PROJECT NO. I-H2-1(17):6

WAIHAWA INTERCHANGE

WAIHAWA INTERCHANGE
SPRINKLER PLAN
AREA "W-2"

WAHIAWA INTERCHANGE & LEILEHUA INTERCHANGE
CONTROL DIAGRAMS

**LEILEHUA INTERCHANGE
SPRINKLER PLAN
AREA "L-3"**

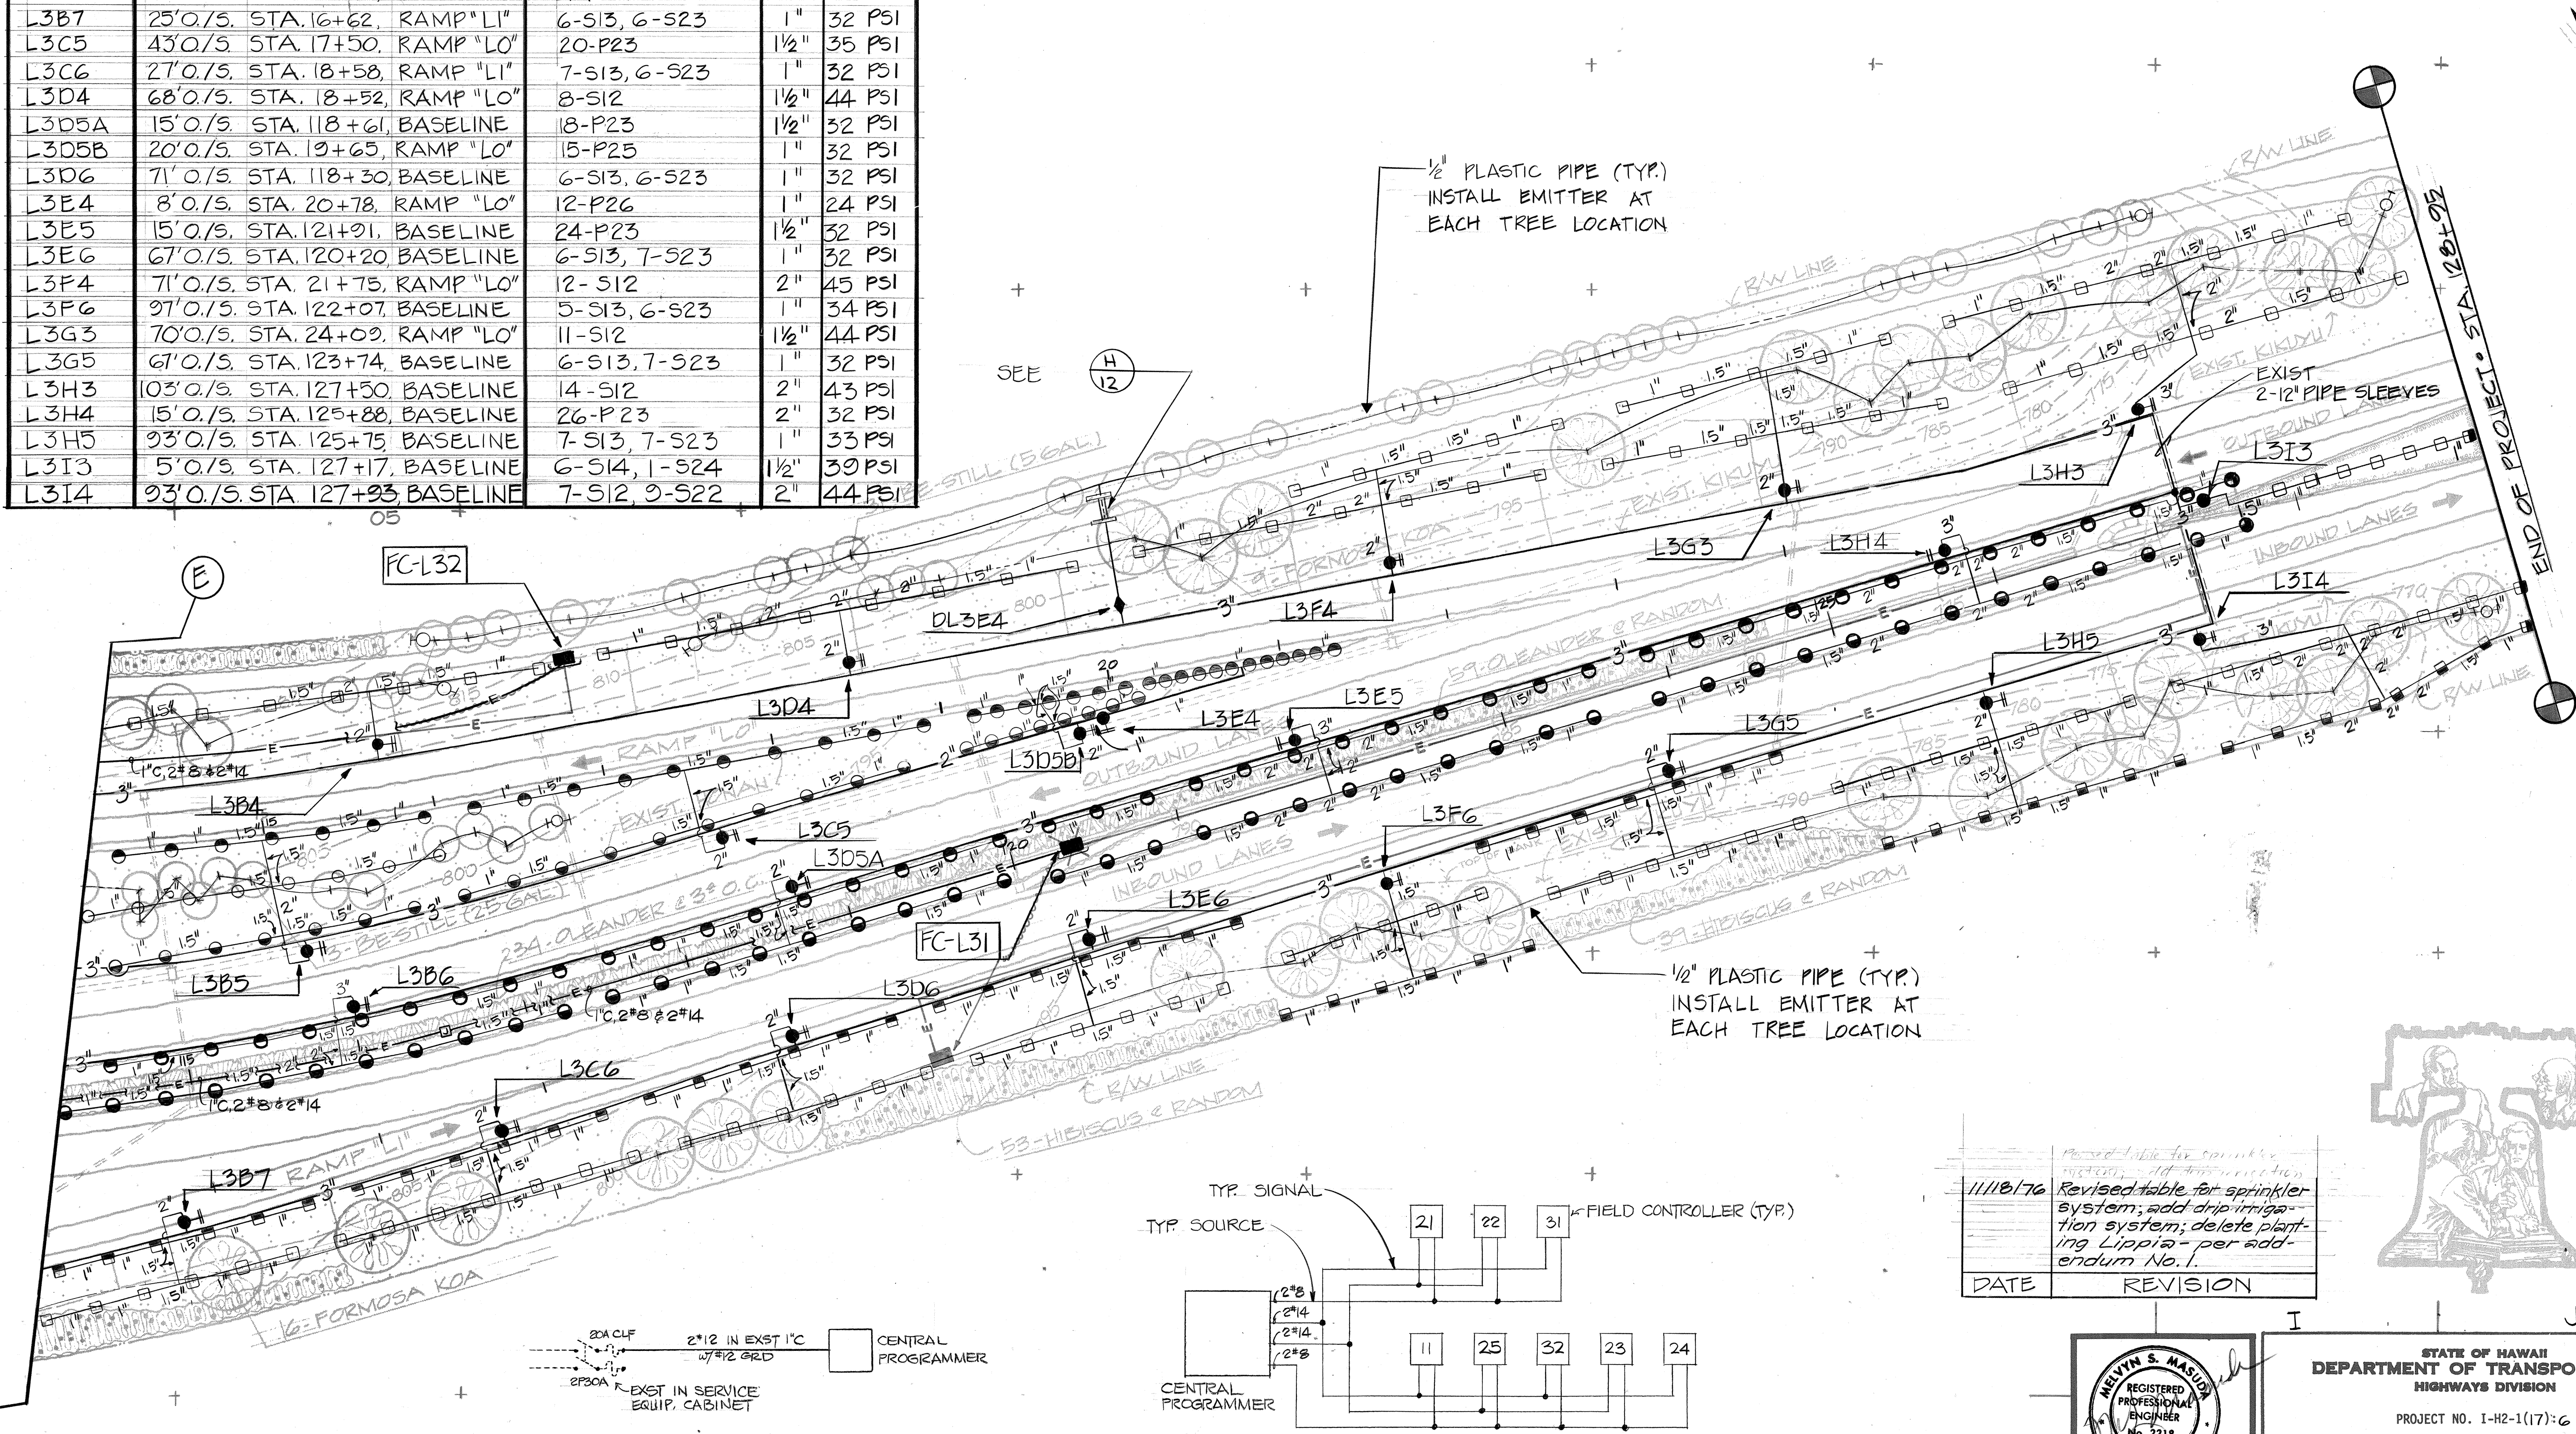
DATE	REVISION
11/18/76	Revised table for sprinkler system; add drip irrigation system; delete planting Lippia - per addendum No. 1.

E
13
BACKFLOW PREVENTER ASSEMBLY
N.T.S.

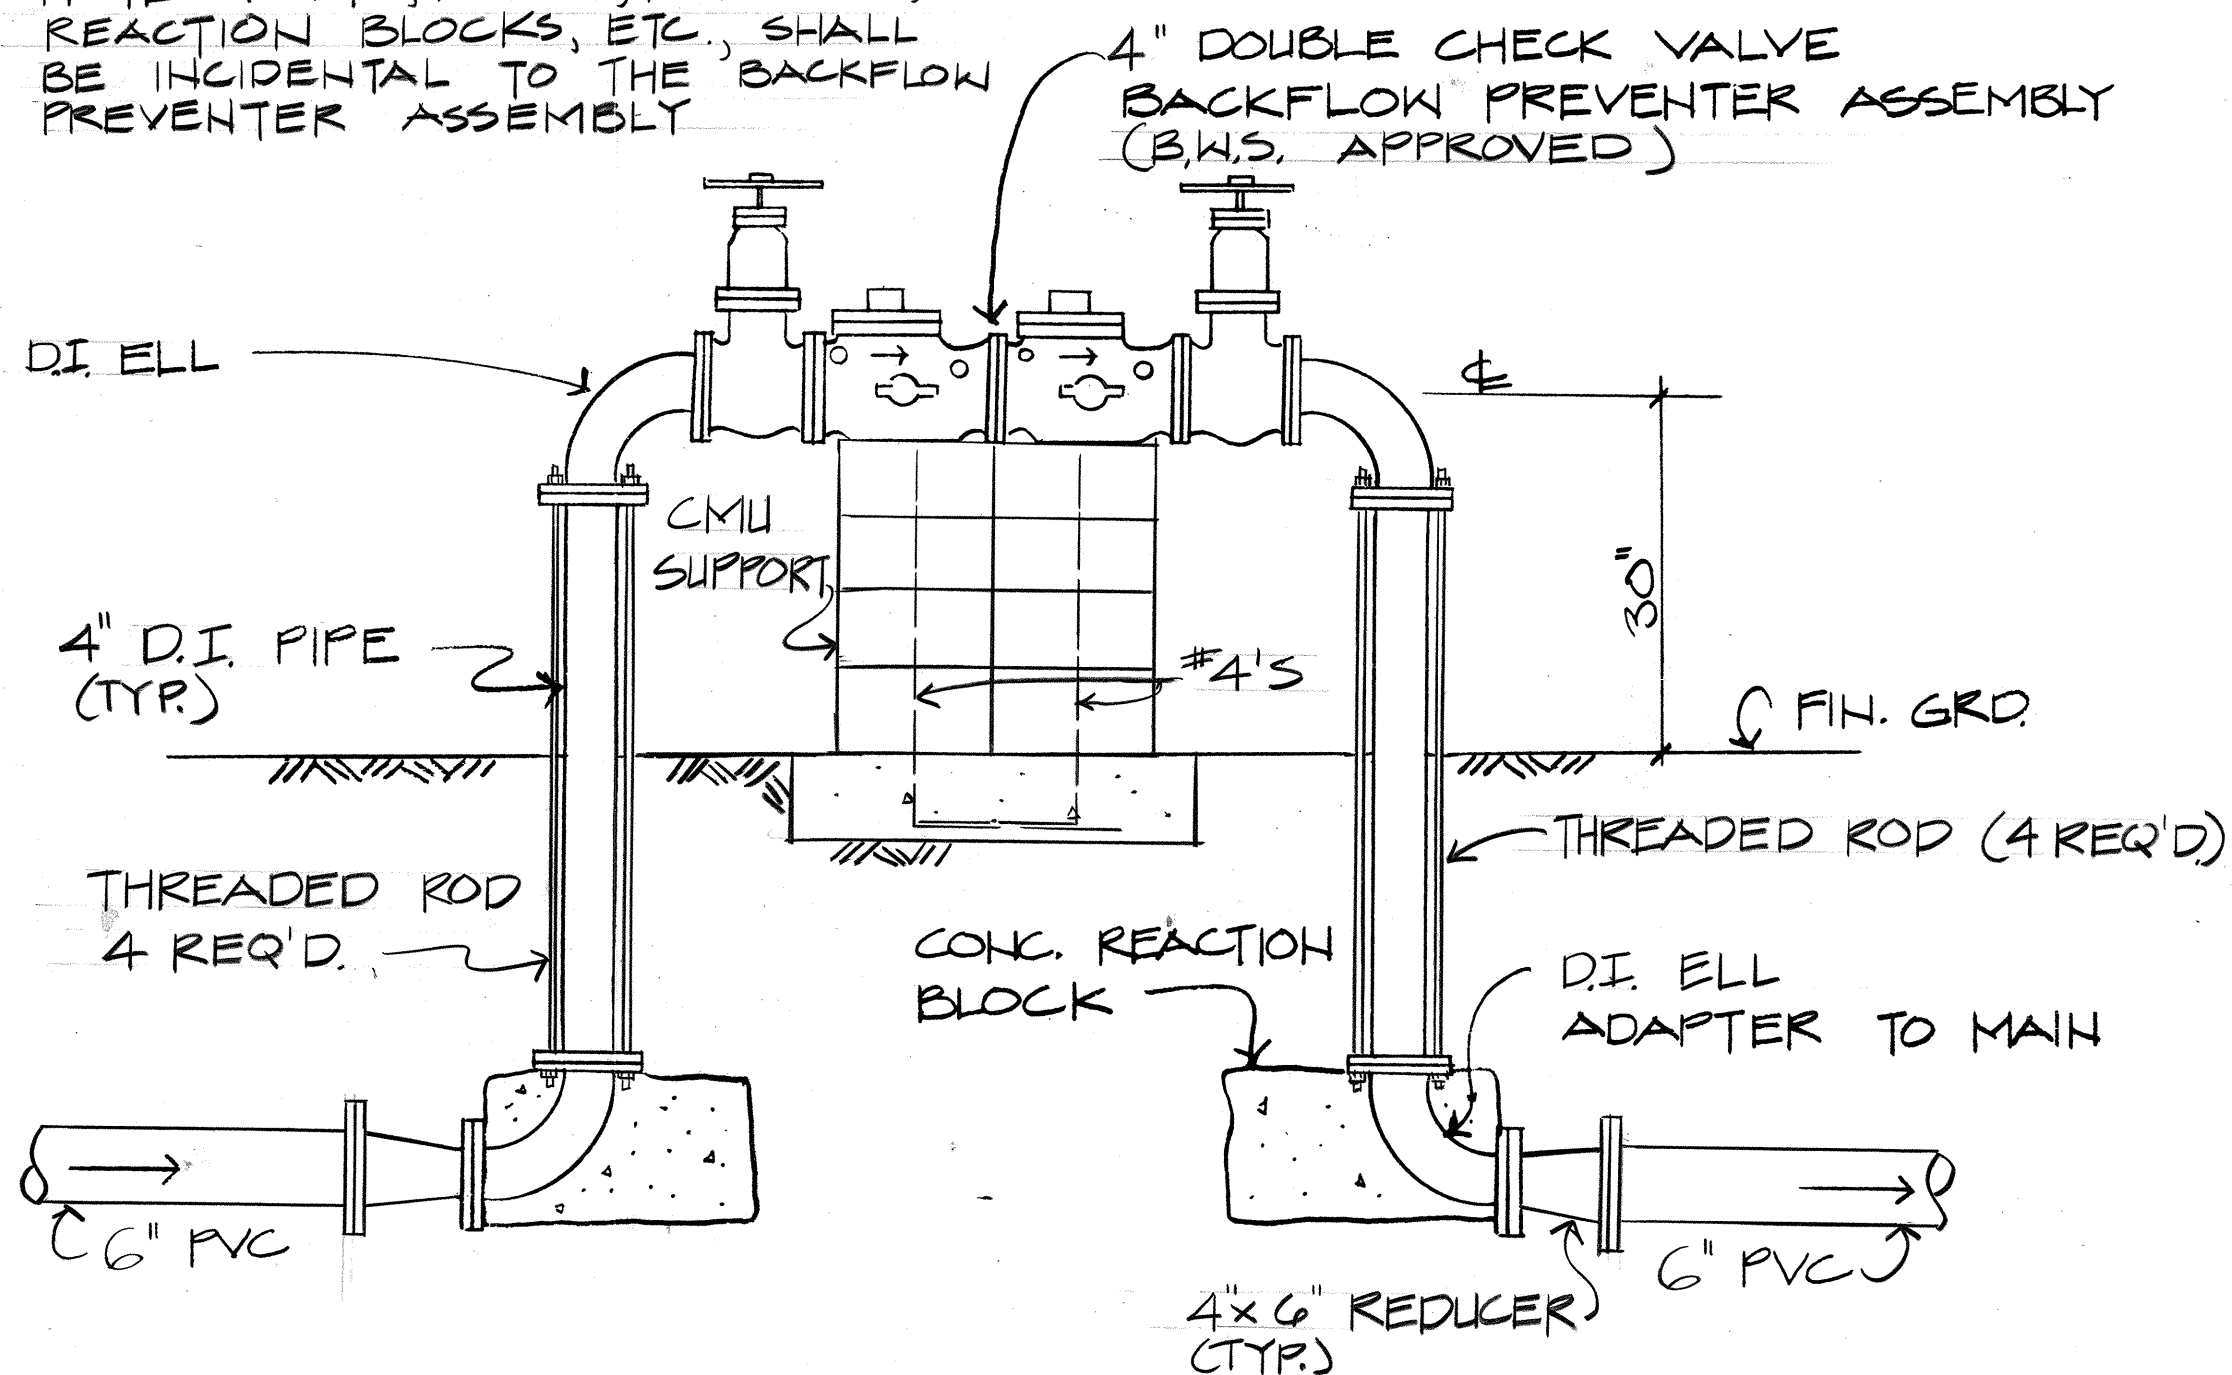
DATE	REVISION
1/11/87	Revised Backflow Preventer Assembly detail - per addendum No. 1.

WAHIAWA INTERCHANGE &
LEILEHUA INTERCHANGE
CONTROL DIAGRAMS

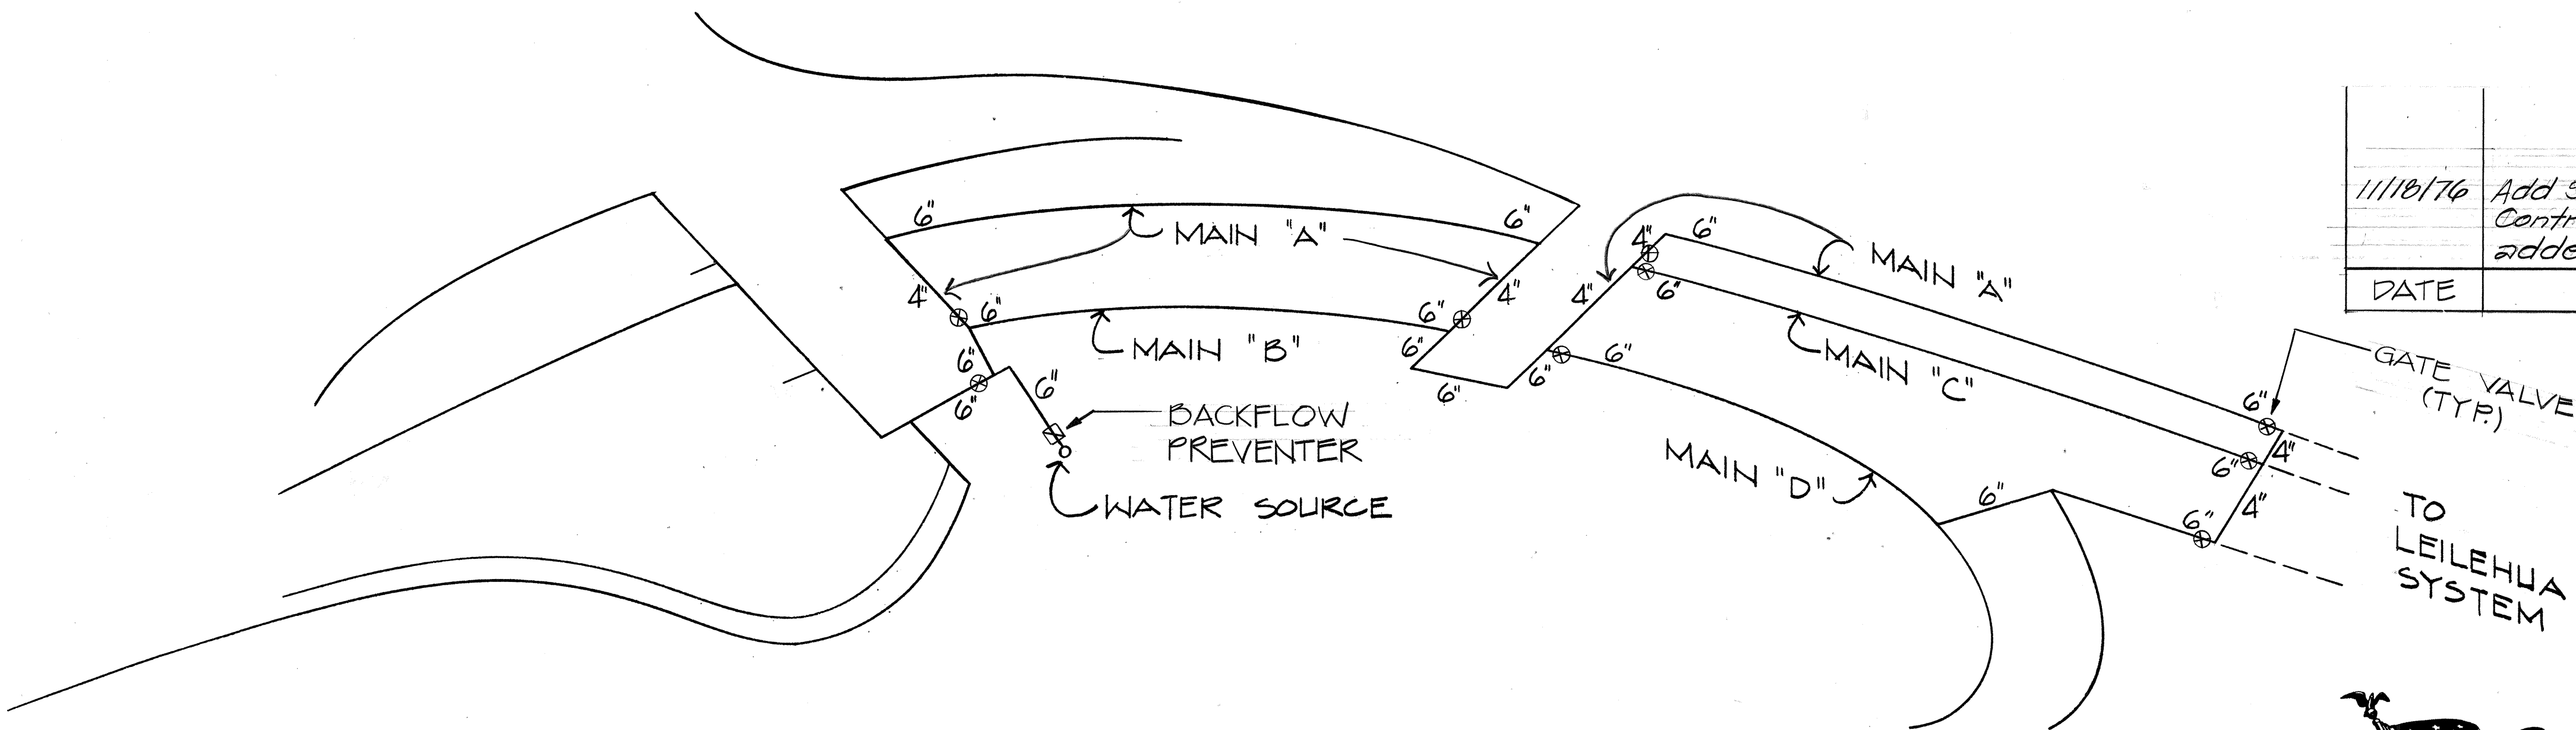
11/18/76	Add Sprinkler Bank L313 to Control Diagram EC-L32 per addendum No. 1
DATE	REVISION
